Sampling and Analysis Plan (Field Sampling Plan/Quality Assurance Project Plan) to Address Data Gaps at Installation Restoration Site 25 (Soil at Kollmann Circle), Site 32 (Groundwater), and Site 35 (Groundwater in Areas of Concern 1 and 23 and Soil in Area of Concern 6)

**Alameda Point
Alameda, California**

**RESPONSE TO COMMENTS
RESPONSES TO REGULATORY AGENCY COMMENTS ON THE DRAFT SAP
(FSP/QAPP) TO ADDRESS DATA GAPS AT IR SITES 32 AND 35
ALAMEDA POINT, ALAMEDA, CALIFORNIA**

EPA's Comments from Anna-Marie Cook, received November 1, 2007

FIGURE 3
IR SITE 32
MONITORING WELL LOCATIONS

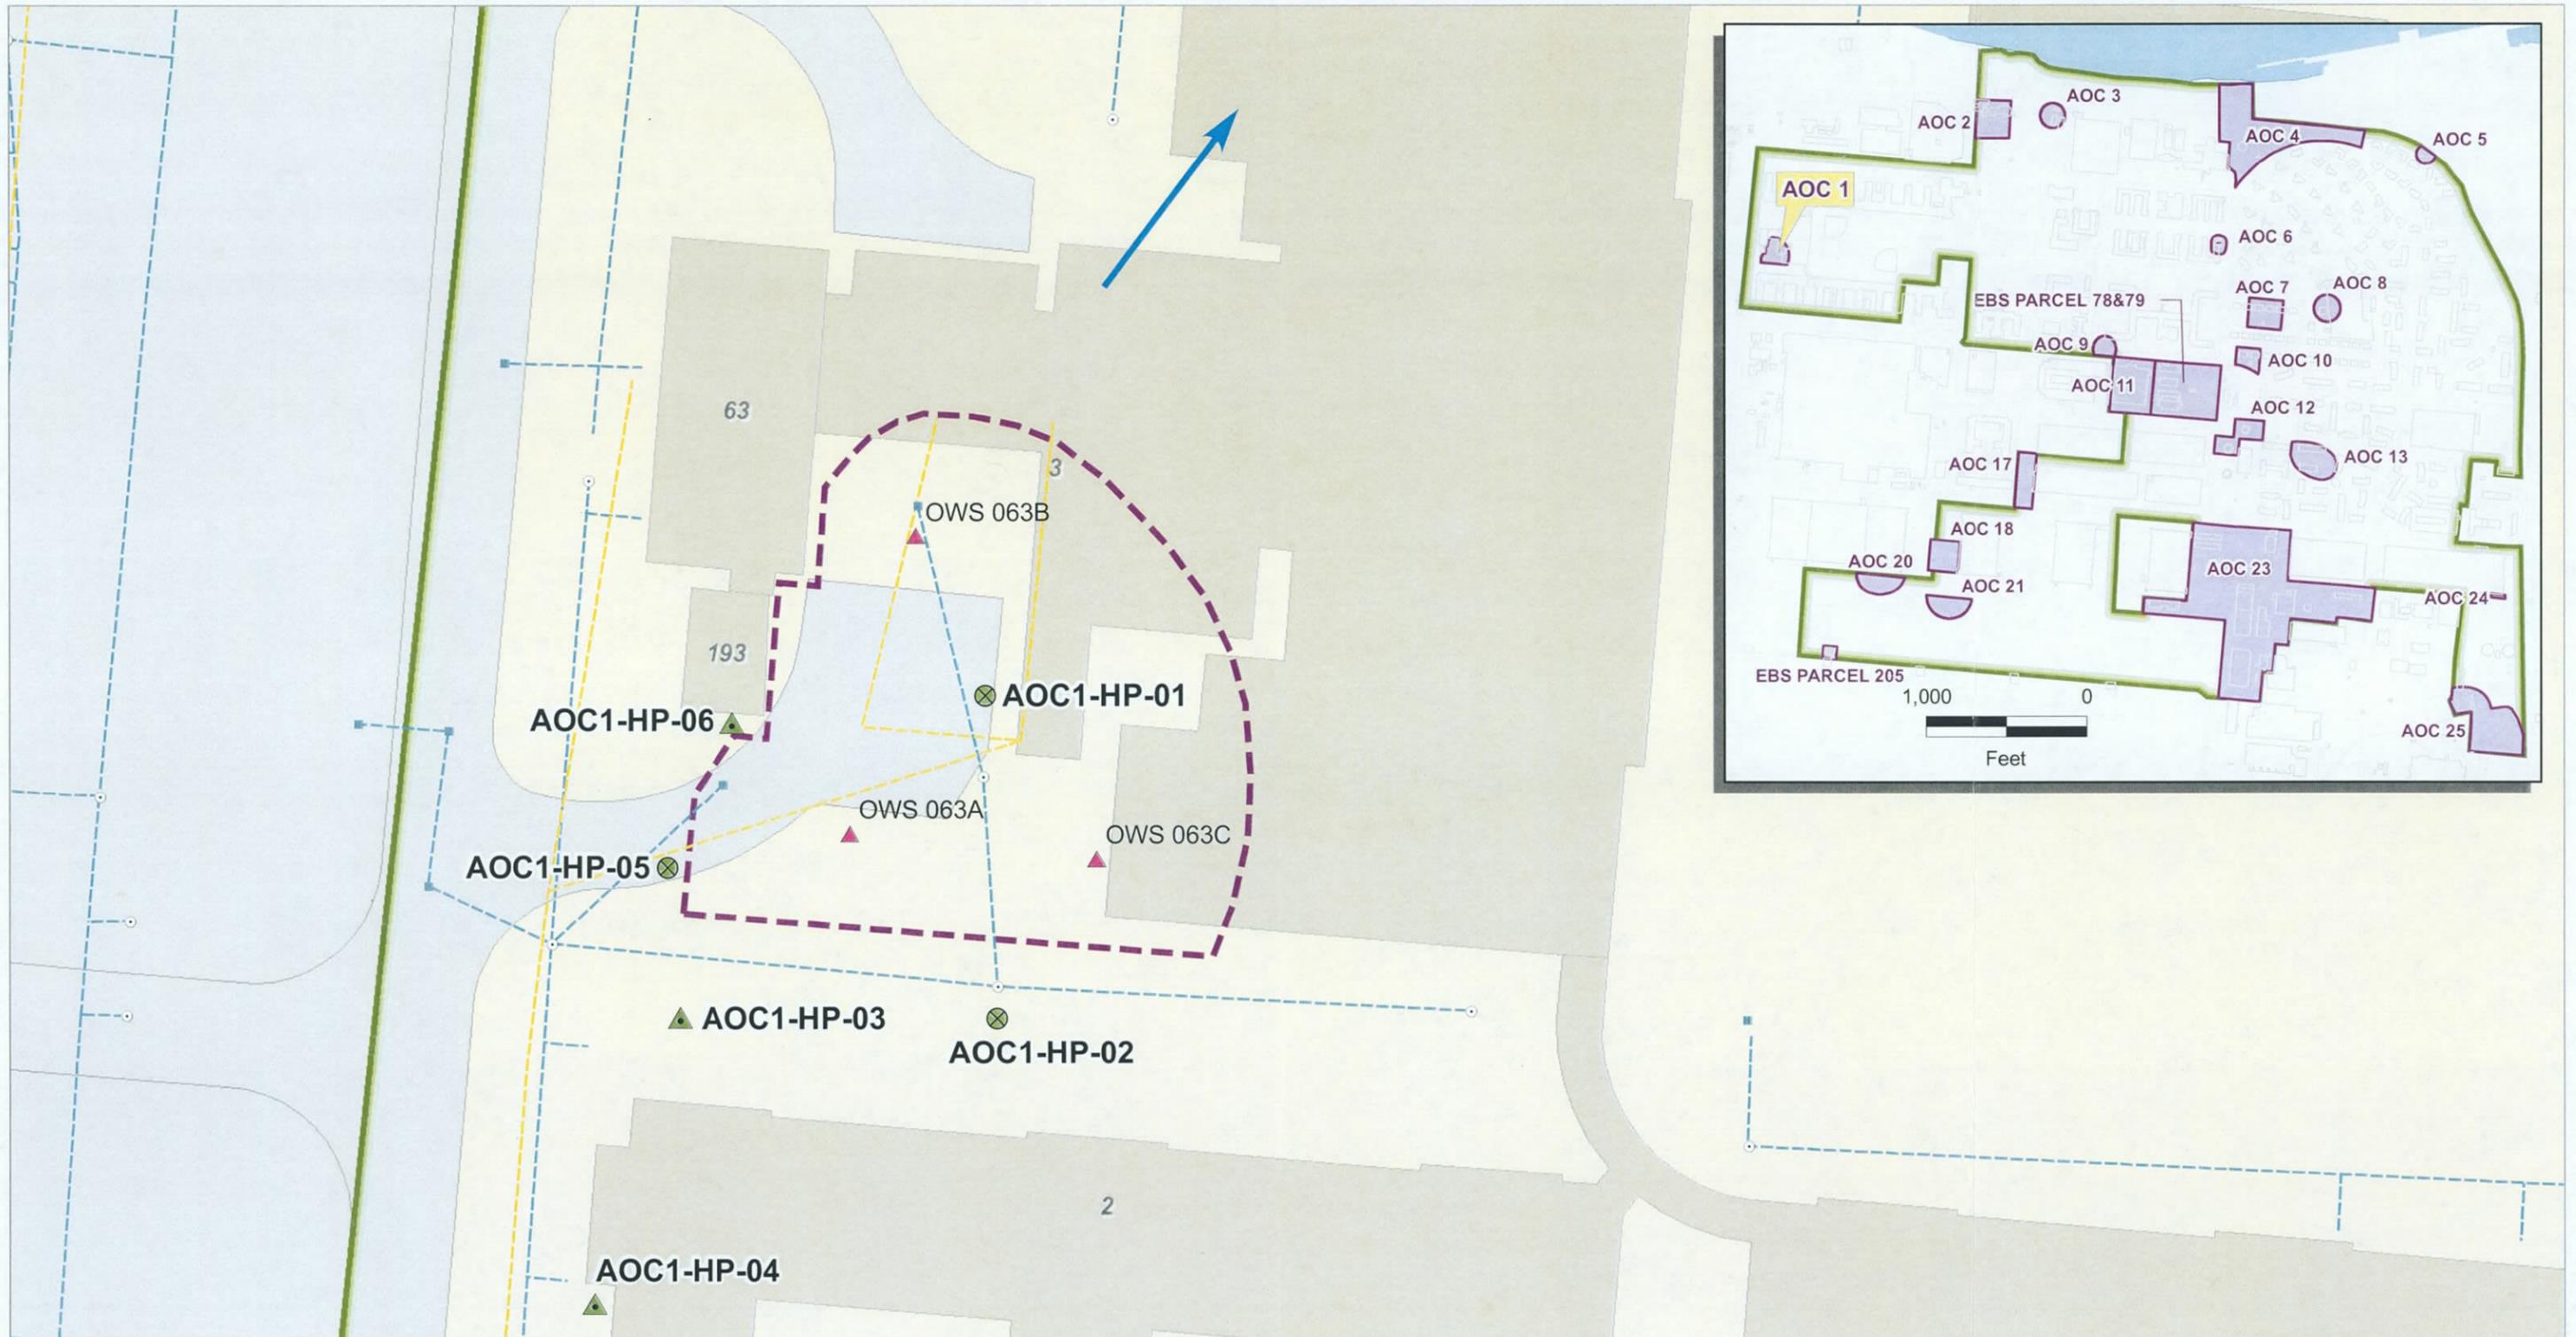
a. This section states that groundwater samples will be collected from six temporary “microwells” as shown on Figure 3. However, Figure 3 shows three proposed “Hydropunch locations” and three proposed “Hydropunch or temporary piezometer locations.” GSU requests that the Navy clarify the difference between microwells, Hydropunch locations, and temporary piezometer locations, as follows:

- **Please clarify the meaning of the term microwells.**
- **Please clarify the methods that will be used for Hydropunch sample collection and clarify the difference between Hydropunch and temporary piezometers.**
- **Please explain why some locations were proposed for temporary piezometer installation and some were proposed for Hydropunch sampling.**

Response: The SAP will be revised to use a consistent terminology. The terms Hydropunch and microwell will be replaced with direct-push. All groundwater samples will be collected in AOC 1 using a direct-push technology such as Hydropunch. No

**FIGURE 6
IR SITE 35 AOC 23 PROPOSED
MONITORING WELL LOCATIONS**

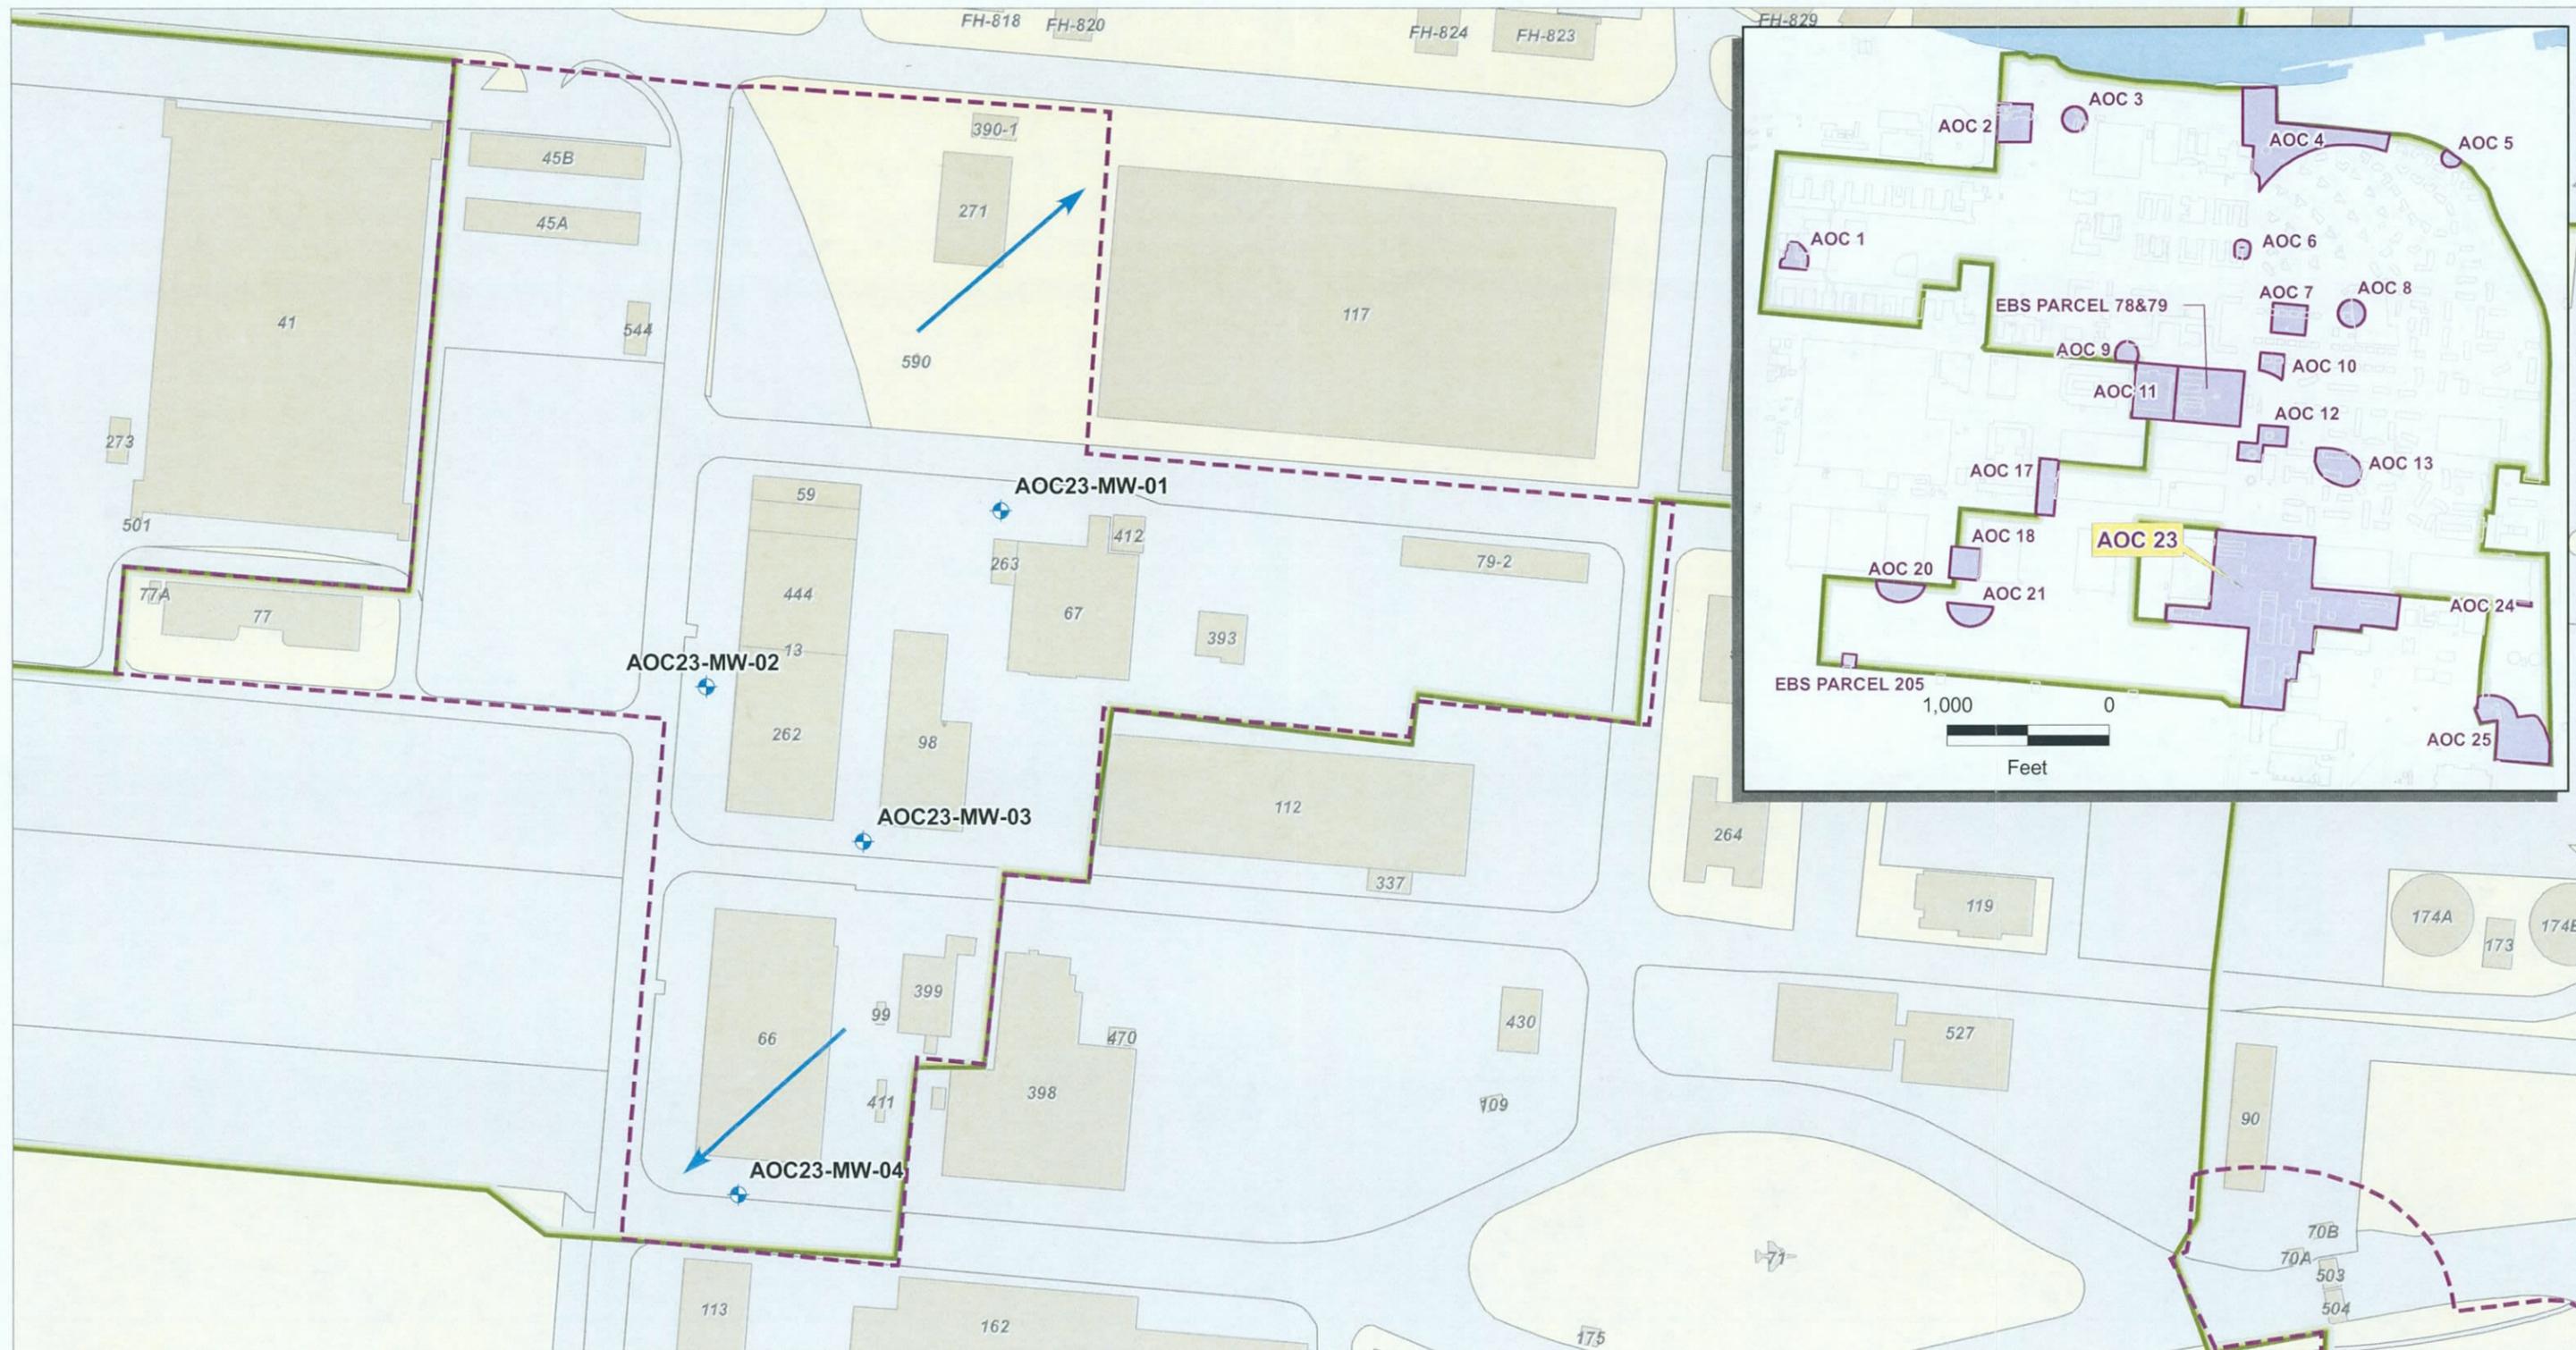
5. **Section 2.1 – Sampling Process Design.** This section states that groundwater sampling at AOC 23 will assess whether vinyl chloride concentrations in groundwater have attenuated to at or below the preliminary remedial goals. GSU questions whether the proposed sampling design will meet this objective since some of the monitoring wells are located in areas where vinyl chloride was not previously detected. One of the proposed wells (AOC23-MW-01) appears to be located upgradient from the area where vinyl chloride was detected and adjacent to a previous sample in which vinyl chloride was not detected. Well AOC23-MW-03 is located cross-gradient to the area where vinyl chloride was detected. AOC23-MW04 is located upgradient of the vinyl chloride detected at S21-DGS-DP20.

Please clarify the rationale for each proposed monitoring well location and consider moving wells, as necessary, to locations that will fulfill the objectives of the sampling program.

- b. **This section states that at AOC 23, groundwater samples will be collected from three new monitoring wells shown on Figure 5. However, Figure 5 shows four proposed monitoring well locations. Please clarify that four monitoring wells will be installed at AOC 23, not three. Please also change the information in Step 3 of the DQOs (Table 3) to indicate that four wells, not three, will be installed and sampled.**

- 1. **Response to Specific Comment 5.** The groundwater flow direction arrow shown on Figure 5 does not support the information provided in this response about the northeasterly component of groundwater flow at AOC23. To avoid confusion, please correct the groundwater flow direction information on Figure 5.

3. **Response to Specific Comment 6(b).** Please identify the existing well in the location of proposed well AOC23-MW-02 that the Navy plans to sample as indicated in this response and show its location on Figure 5. Please include a reference to the document that provides supporting information about the installation, development, and construction details of this existing monitoring well.

Response: The monitoring wells for AOC 23 are intended to confirm concentrations previously observed and determine if there is a vinyl chloride plume that would require remediation. The monitoring well at the northwest corner of Building 67 (AOC23MW-01) is near the location of the highest vinyl chloride concentration in groundwater observed in the site 35 remedial investigation report. The groundwater flow direction in the vicinity of AOC 23 is complex. In the area of MW-01, the remedial investigation report indicated that groundwater flow is to the northeast. Consequently, AOC23MW-01 is located downgradient of the highest reported concentration of vinyl chloride in groundwater. The monitoring well identified as AOCMW23-03 is located near the highest concentration of vinyl chloride reported in soil.

The Navy believes the wells are located appropriately to achieve these objectives. The figure has been revised to show the groundwater flow directions shown by the Site 35 remedial investigation report.

Response: The figure will be modified to show that 4 new monitoring wells will be installed. A total of 4 groundwater samples will be collected from 4 new wells.

Response: The figure has been revised to show groundwater flow as depicted in the Site 35 Remedial Investigation Report.

Response: No well construction information could be found for the existing well. Consequently, the Navy will go forward with its original intention and install a new well. Comment 6(b) has been revised.
